UNITED STATES PATENT AND TRADEMARK OFFICE

10/527,228

Office Action Summary	Application No.	Applicant(s)	
	10/527,228	KRAUSE ET AL.	
	Examiner	Art Unit	
	Helena Kosanovic	3749

DETAILED ACTION

5. Gillick (fig. 4) and Weber (Fig. 1) with originally unlabeled element relevant in examination labeled by Examiner for clarification.

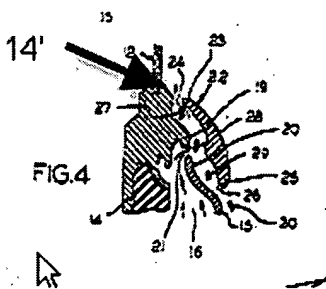
Gillick teaches a vent module (figs. 2-4) having a plurality of vents 26 (fig.4) each separated by ridge 31 (fig.2); an upper sealing lip 23, 14' (fig. 2) in contact with window 12 having a port 24 (col. 3, ll. 12-15);

It would have been obvious to one ordinary skill in the art to have the Weber air vent module for window modified with the Gillick upper lip with port in order to enhance the flow of air upwardly out the opening 24 (col. 3, ll. 12-15) .

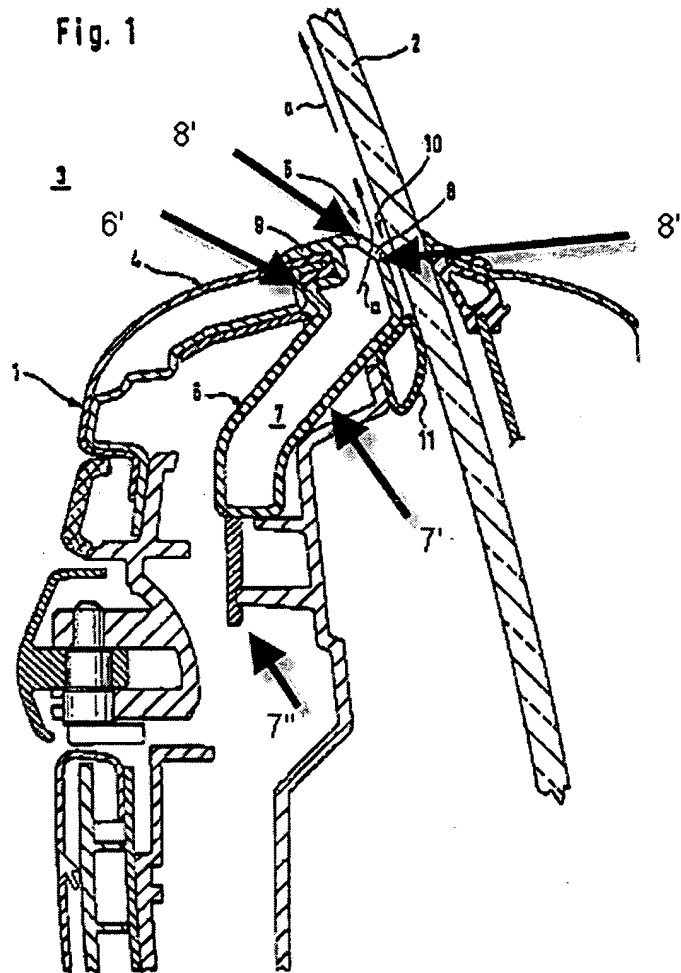
Weber teaches invention as claimed: an air vent module for window panels 2, having a tubular duct 7 disposed in the door cavity with at least one vent opening 8 (fig 1), extending in an upright direction roughly parallel to the window panel (fig. 1) wherein vent opening 8 having an upper edge 8' located below a top surface 9 of duct 7 (fig. 1) and lower edge 8" leveled with a bottom surface 7' of said duct; a lower sealing lip 11 in contact with window 2 (fig. 1) for jetting said window with air-flow emerging from vent 8 in region of lower edge 8" where dictionary defines “emerge”: to come forth into view or notice, as from concealment or obscurity

(<http://dictionary.reference.com/browse/emerge>, accessed 9/22/06), therefore sealing lip 11 comes forth into view from obscurity and thus meets the claim limitation; an upper sealing lip 9 secured to said duct in contact with said window and spaced away from lower sealing lip 11 (fig. 1) wherein upper sealing lip is "positively" connected to duct 6 and 4 (fig. 1) and having an appendage 6', located in the groove of duct 4; a flange secured to the inner wall of door cavity 1 (fig. 1) orthogonally from duct 7.

Weber is silent about having a upper sealing lip in contact with said window panel having a ports.
